P 515986

A REPAIR

ON-SITE SEWAGE DISPOSAL SYSTEM
HOWARD COUNTY HEALTH DEPARTMENT
BUREAU OF ENVIRONMENTAL HEALTH

ADDRESS: 12289 Scaggsville Road PROPERTY OWNER: Floyd Ray Taylor

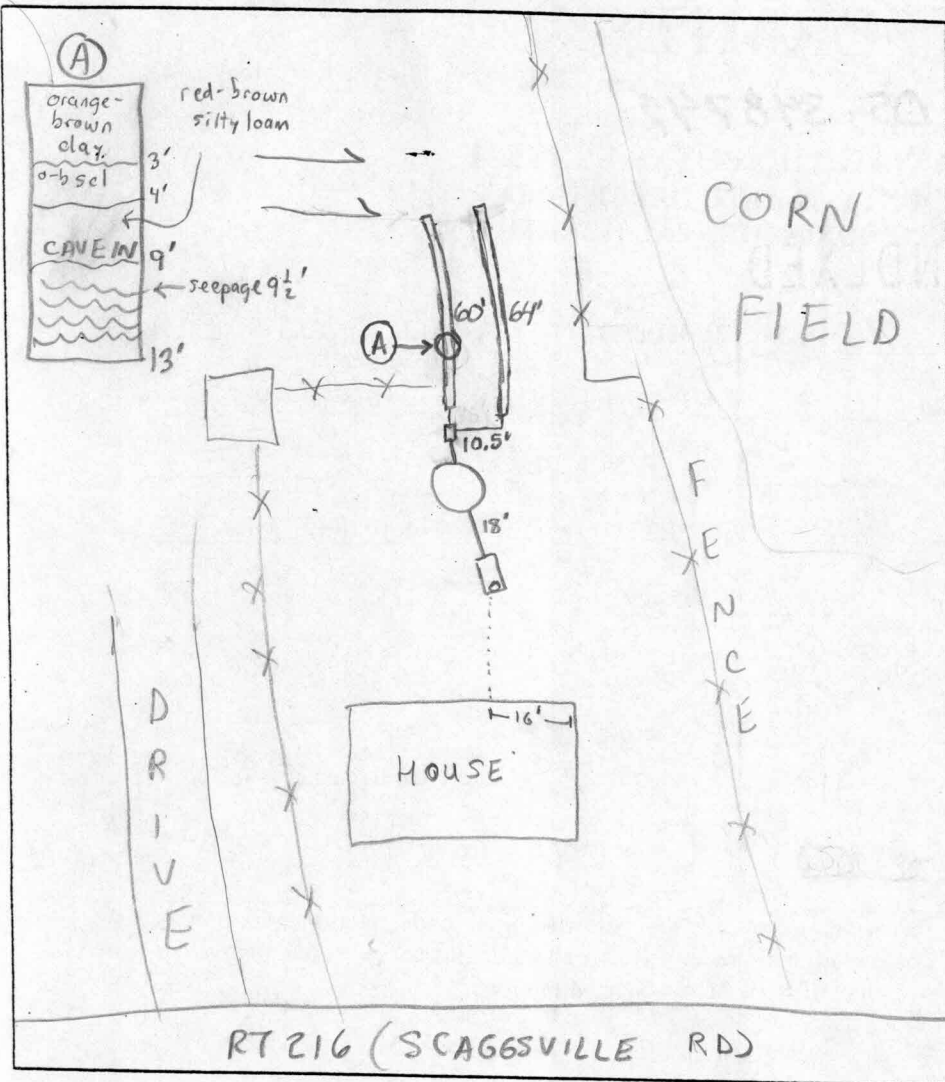
PRE-CONSTRUCTION INSPECTION: 8/21/01-D46 PERC HOLE AT (A), INSTALL PER SPECS ON FRONT, REPLACE PIPE FROM EX. TANK TO DW W/PVC, INSTALL NEW 6" CLEANOUT ON ST (SR)

INSPECTION COMMENTS: 8/22/01 System satisfactory. O.K. to cover. (BB)
